[1] 7/25/2008
TEDD APPROVAL
REDLINE REVISION
07/21/2008

MD 70 (BESTGATE ROAD/ROWE BOULEVARD)
AT NORTH BESTGATE ROAD/TIDEWATER COLONY DRIVE

TRAFFIC SIGNALIZATION PLAN

TS NO. 3396E — DRAWING SG-01 OF 02 — SHEET NO. 1 OF 2

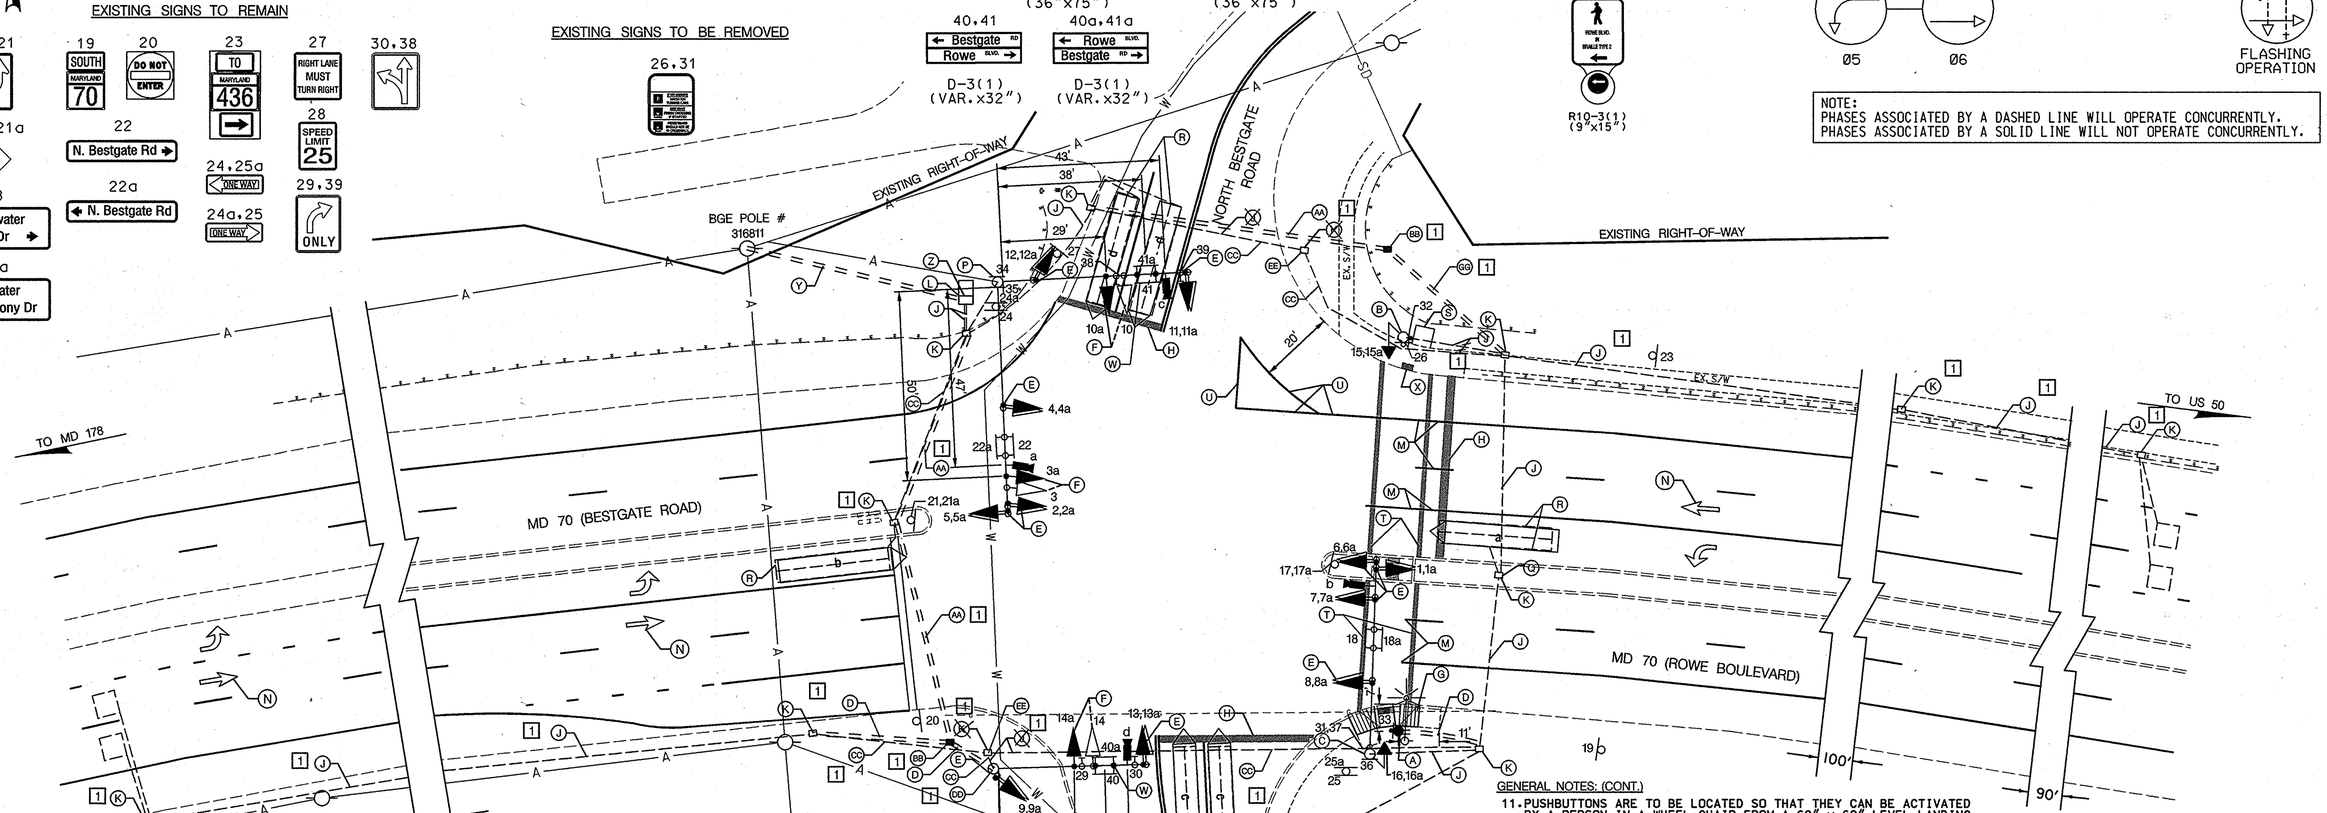
Z. INSTALL 2 IN. CONDUIT BEND IN EXISTING CONTROLLER CABINET FOUNDATION.
[1] AA. INSTALL 4 IN. SCHEDULE 80 RIGID PVC ELECTRICAL CONDUIT (BORED).
BB. INSTALL ELECTRICAL HANDHOLE.
[1] CC. CAP AND ABANDON EXISTING CONDUIT.
[1] DD. INSTALL 3 IN. CONDUIT BEND IN EXISTING FOUNDATION.
[1] EE. ABANDON EXISTING HANDHOLE.
[1] GG. INSTALL 4 IN. SCHEDULE 80 RIGID PVC ELECTRICAL CONDUIT (TRENCHED)
